HISTORIC AND DESIGN REVIEW COMMISSION

February 06, 2019

HDRC CASE NO: 2018-462
ADDRESS: 201 E HUISACHE AVE
LEGAL DESCRIPTION: NCB 3085 BLK 1 LOT 23
ZONING: MF-33, H
CITY COUNCIL DIST.: 1
DISTRICT: Monte Vista Historic District
APPLICANT: Patrick Christensen
OWNER: SA Huisache Investors LLC
TYPE OF WORK: Window replacement
APPLICATION RECEIVED: January 16, 2019
60-DAY REVIEW: March 15, 2019
REQUEST:

The applicant is requesting a Certificate of Appropriateness for approval of a window master plan in response to the commission action at the HDRC hearing on August 19, 2018.

First floor
O = old wood
X = new vinyl

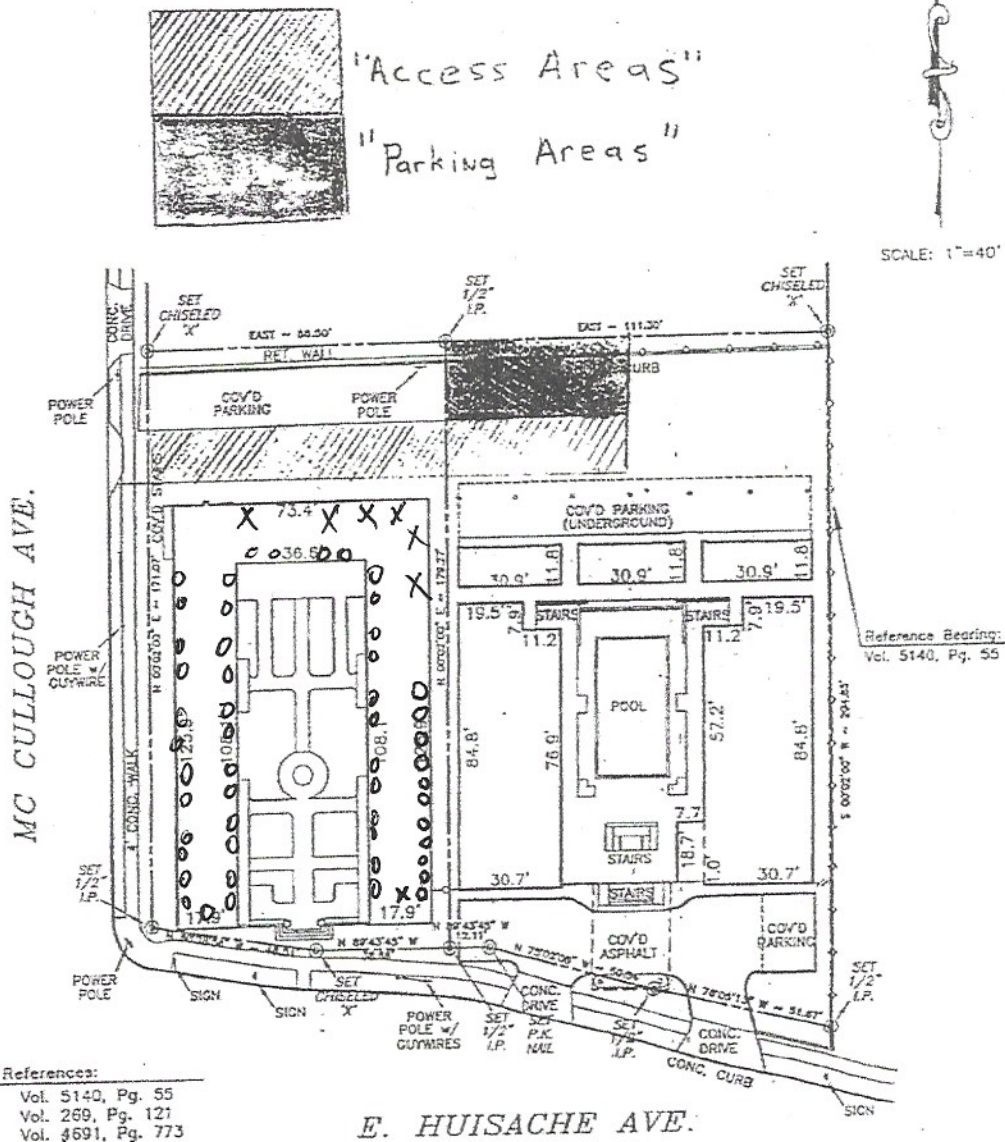
Please find attached site plan showing the 25 replaced windows. I only intended to replace two more units (total 27) as the replacement was in response to significant water infiltration issues and damage to frames and sills from neglect of previous ownership. We repaired and replaced significant areas of the roof and kept the tile roof as well to solve this and keep with the character of the building. We have replaced second floor balcony doors, but with wood (not vinyl).
